ERL (Effective Return Loss) Proposal

Addressing comments i71 to i77 (and others) for IEEE P802.3cd D3.0:

Richard Mellitz, Samtec

January , 2018

ERL Distribution for: Posted .3cd and .3by Cable Assembly and Backplane Channels

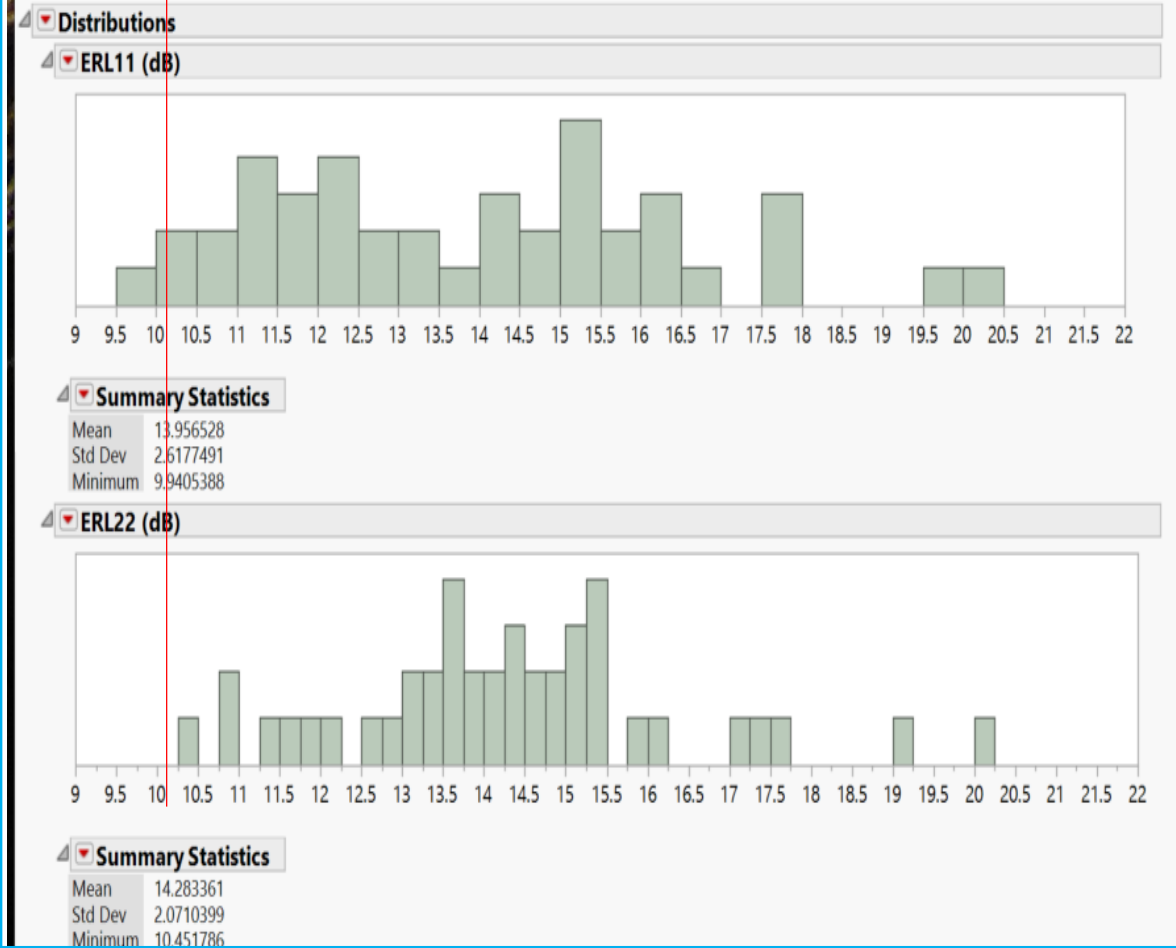
Proposed limit

Proposed limit
